UNITED STATES PATENT AND TRADEMARK OFFICE

APPLICATION NO.	FILING DATE	FIRST NAMED INVENTOR	ATTORNEY DOCKET NO.	CONFIRMATION NO.
10/799,396	03/12/2004	Young-Joon Rhee	AB-1355 US 7324	
32605 MACPHERSO	7590 12/18/2007 N KWOK CHEN & HE	EXAMINER		
2033 GATEWAY PLACE SUITE 400 SAN JOSE, CA 95110			CHIEN, LUCY P	
			ART UNIT	PAPER NUMBER
			2871	
			MAIL DATE	DELIVERY MODE
			12/18/2007	PAPER

DETAILED ACTION

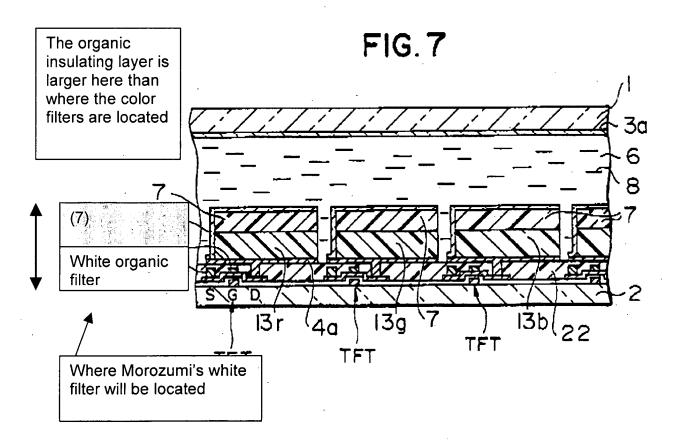
Kataoka et al teaches in Figure 17 an insulating substrate (2), a plurality of thin film transistors (TFT) formed on the substrate (2). A plurality of three primary color filters (13r,13g,13b) formed on the substrate (2). A plurality of first pixel electrodes (4b) formed on the color filters (13r,13g,13b) and connected to the thin film transistors (TFT) to complete a liquid crystal display with color filters.

Kataoka et al does not disclose the second pixel electrode on the substrate and an organic insulating layer including a plurality of first portions disposed between the color filters and the first pixel electrodes and a plurality of second portions disposed under the second pixel electrodes and having thickness larger than the first portions.

Morozumi discloses (Fig. 16) (column 10, row 48-60) the use of a second pixel electrode (associated with a white filter or transparent filter) used to brighten the display. When adding Morozumi's white filter (which is an organic insulating layer also) to Kataoka et al's display (Fig. 7) it will be manufactured the same and thus the organic

insulating layer (7) including a plurality of first portions disposed between the color filter (13r,13g,13b) and the first pixel electrode (4b) and a plurality of second portions (which is Morozumi's white organic insulating filter and the insulating layer (7) of Kataoka et al under the second pixel electrodes has a thickness larger than the first portions (7 shown above 13r,13g,13b)

Applicant's arguments on page 7 says "the phase shifter layer 7 I s not an organic insulating layer. The phase shifter layer 7 is formed from a polymer containing liquid crystal molecules." Is not persuasive. A polymer is organic. Even if it contains liquid crystal, its still an organic insulating layer.

Applicant's arguments that "..the overlying phase shifter layer 7 would be the same thickness portion of layer 7 over the RGB portions. Examiner is calling the plurality of second portions, which is Morozumi's white organic insulating filter <u>and</u> the insulating layer (7). Thus, the second portion (Morozumi's white organic insulating filter <u>and</u> the insulating layer (7)) disposed under the second pixel electrodes has a thickness larger than the first portion (portions located between COLOR (RGB) filter and pixel electrod).
